Access Compliance Report

Public Rights-of-Way

Intersection ID: 10036867	Main Street: S_KINGS_DR	Cross Street: N/A	Location: NW
ADA ID: 28CDDCB12429	Ramp Type: PerpDiag	Initial Pass/Fail: Fail	Overall Compliance: No
		Severity Score: 12.5

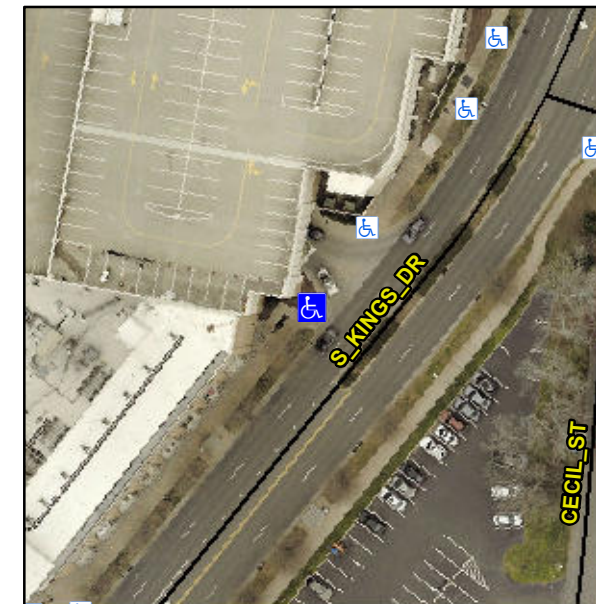
R304.2.2

Compliance	Description	Data	Compliance	Description	Data
N/A	Ramp Length (in)	48.0	No	Ramp Slope (%)	9.9
Yes	Ramp Width (in)	48.0	Yes	Ramp XSlope (%)	1.2
N/A	Flare Type LT	N/A	N/A	Flare Type RT	N/A
N/A	Flare Slope LT (%)	N/A	N/A	Flare Slope RT (%)	N/A
N/A	Flare Traversable LT?	N/A	N/A	Flare Traversable RT?	N/A
N/A	Landing Length (in)	N/A	N/A	DWS Provided?	N/A
N/A	Landing Width (in)	N/A	N/A	DWS Contrast?	N/A
N/A	Landing Slope (%)	N/A	N/A	DWS Length (in)	N/A
N/A	Landing X Slope (%)	N/A	N/A	DWS Full Width?	N/A
N/A	Landing Curb? (Y/N)	N/A	N/A	DWS Offset (in)	N/A
N/A	Shared Landing?	N/A			
N/A	Gutter Ponding?	N/A	N/A	Gutter Slope (%)	N/A
N/A	Gutter Lip Ht (in)	N/A	N/A	Gutter X Slope (%)	N/A
N/A	Painted X Walk1?	No	N/A	Painted X Walk2?	No
	X Walk 1 Direction	To SE		X Walk 2 Direction	To NE
N/A	X Walk 1 Width (in)	N/A	N/A	X Walk 2 Width (in)	N/A
	X Walk 1 Slope (%)	2.0		X Walk 2 Slope (%)	1.1
	X Walk 1 X Slope (%)	0.9		X Walk 2 X Slope (%)	1.7

Remove & Replace Curb Ramp With Two New Directional Ramps or Equivalent.
